19 December 2025

Buller District Council
PO Box 21
WESTPORT 7866

JOHN RAYMOND MCLAUGHLIN – RC250005 REQUEST FOR FURTHER INFORMATION UNDER S92

Scale: 1:10

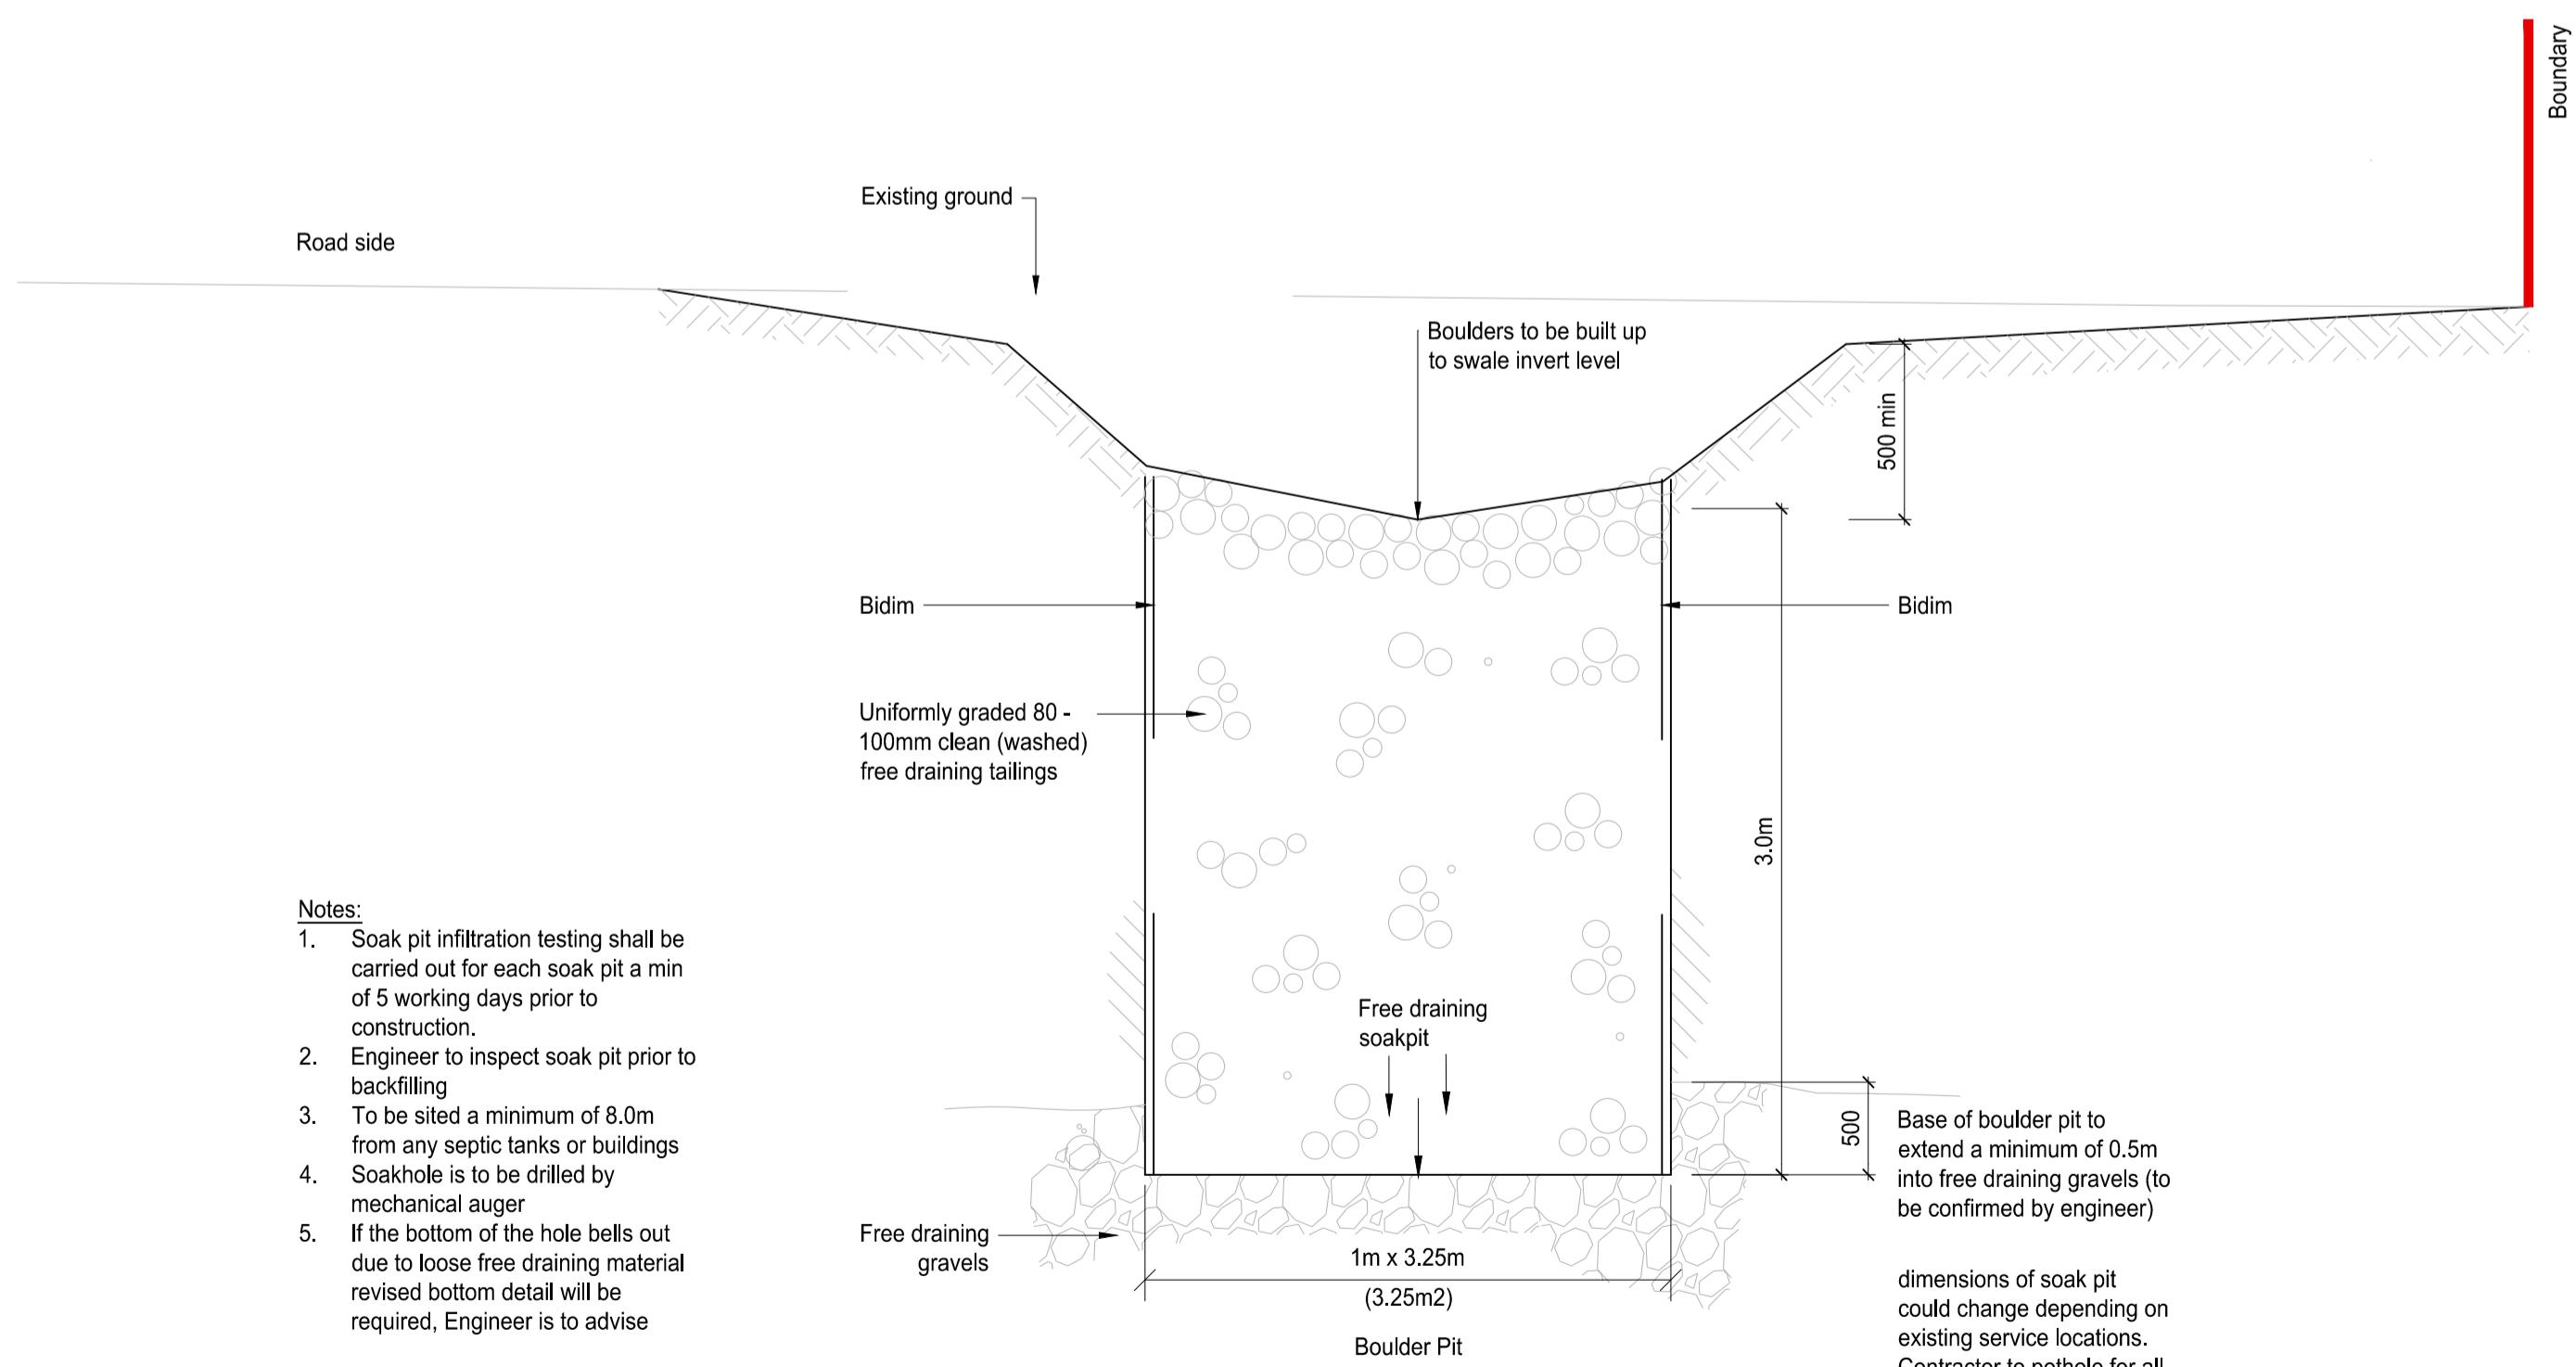
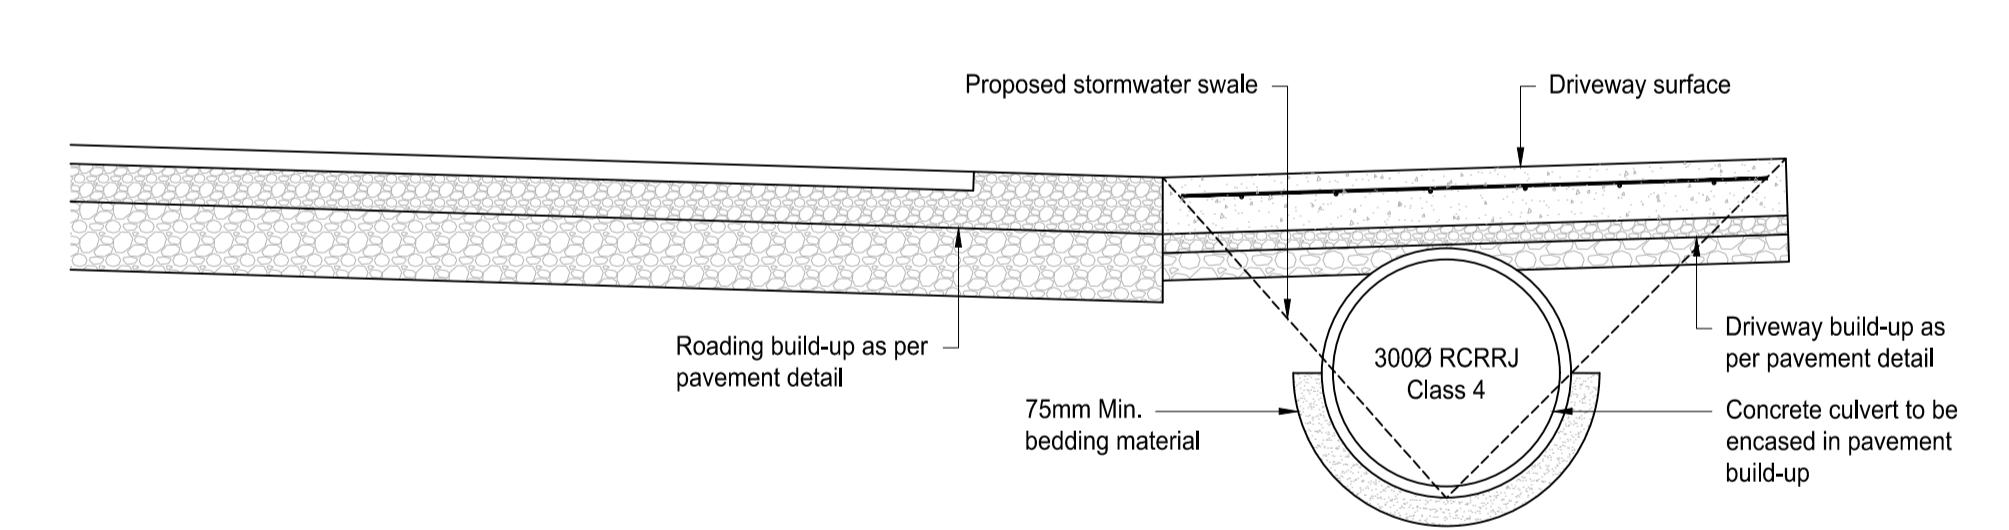
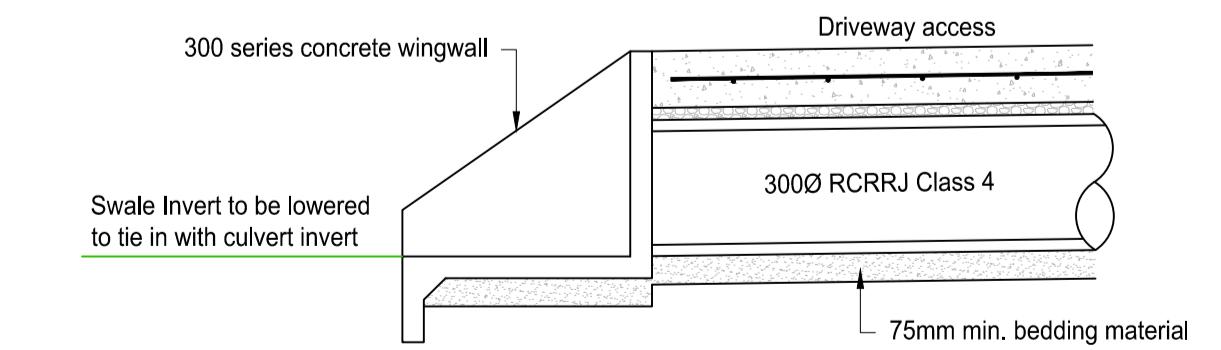
10. Provide a Design and Access Statement, prepared by suitably experienced chartered professional engineer practising in civil engineering, in accordance with NZS4404:2010 for the proposed road/rights of way, including turning head, and vehicle crossings (including stormwater design and any culvert designs/assessment as required). A signed Schedule 1A Certificate must be submitted with the Design and Access Statement.

Point 10 of the RFI letter requires a Design and Access Statement to be prepared by a suitably experienced chartered professional practicing in civil engineering.

The right of way is to be formed and approved as per New Zealand Standard NZS4404:2010 requirements prior to s224 certification. As per Table 3.2 Figure E2 the right of way will have a minimum formation width of 6 metres, with a shoulder width of 3.5 metres. The legal width is to be 20 metres to enable the formation of the right of way whilst proving space to upgrade the right of way to a road if deemed appropriate in the future or if a hearing is held on this proposal and the commissioner deems the right of way should be a road vested in Council.

Concept plans for the right of way are attached as **Appendix D**. These concept plans are to show the initial design of the right of way. Detailed design of the right of way is expected to be required as a condition of consent.

We request that a condition is included in the consent that requires the design and access statement to be completed by a Chartered Professional Engineer practising in Civil Engineering and submitted to Councils Infrastructure Services department for approval prior to the construction of the right of way. This will enable the engineers to assess the ground conditions in more detail and create a detailed design that accurately reflects the specific ground conditions, while meeting the requirements of NZS4404:2010. The design and access statement will then ensure the design is assessed against the requirements of NZS4404:2010 including, but not limited to, the road dimensions and layout, link and place functions, connectivity, how target operating speeds will be achieved, and the management of stormwater. It will also evaluate the effects of the proposed subdivision on the surrounding communities and network. Requiring the Design and Access Statement to be provided to Council prior to design and construction as a condition of consent, is considered the best, most practical and feasible option to ensure the right of way is accurately designed and constructed to reflect the nature of the landscape.
